- **Proposal:** Demolition of existing structures and the construction of 8-12 storeys mixed-use development consisting of 4 multi-storey buildings containing 290 residential apartments and 1413m<sup>2</sup> of commercial/retail floor space above 3 levels of basement car park and associated landscaping.
- Location: Lot 101, DP 717004, Lots 3 & 4, DP 524149, No. 48 Court Road and 356-358 The Horsley Drive, Fairfield.
- **Owner**: Ausia Funeral Services Pty Ltd
- Proponent: Tallahon Pty Ltd

- **File No:** DA 687.1/2014
- Author: Nelson Mu, Senior Development Planner Fairfield City Council

#### RECOMMENDATION

#### Figure 1: Source: Fairfield City Centre DCP 2013

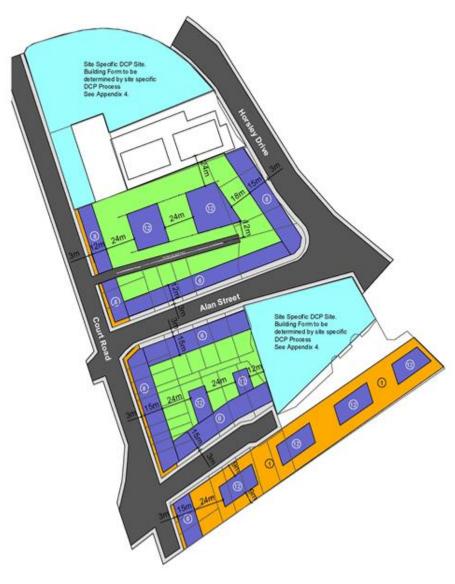
The proposed development generally follows the built form identified in Figure 4.7-3 of the Fairfield City Centre DCP (See below Figure 1 for details). The development, however, does not comply with the required 24metres building separation between the 12-storey tower buildings (Block B and Block C) and between the 12-storey tower building (Block B) and the perimeter building fronting Court Road (Block A). Moreover, the required 18m separation between Block C and Block D is not observed.

The building separations identified in the DCP are generally designed to address critical amenity issues in respect to visual/acoustic privacy and overshadowing between buildings and in response to the building separation requirement of SEPP 65. The desired built form for the site, as conceived in the DCP, is to specifically to address these issues and ensures that any proposal for the site would provide high level of residential amenity within the site and does not prejudice the development potential of any neighbouring properties when they are redeveloped.

In response, the applicant has amended the development where the building separation between Block B and Block C for the first 8 levels have been increased to 18m and the building separation increased to 24m above the 8<sup>th</sup> level. The increased building separation to Block B and Block C to 18m is consistent with the recommended minimum building separation as identified by the RFDC. The increased building separation between these buildings now appropriately address visual/acoustic privacy issues as well as overshadowing within the site. In doing so, the podium communal open space for the development has been increased so as its ability to receive greater solar access in winter and the extent of overshadowing of the southern adjoining sites facing Alan Street has been reduced.
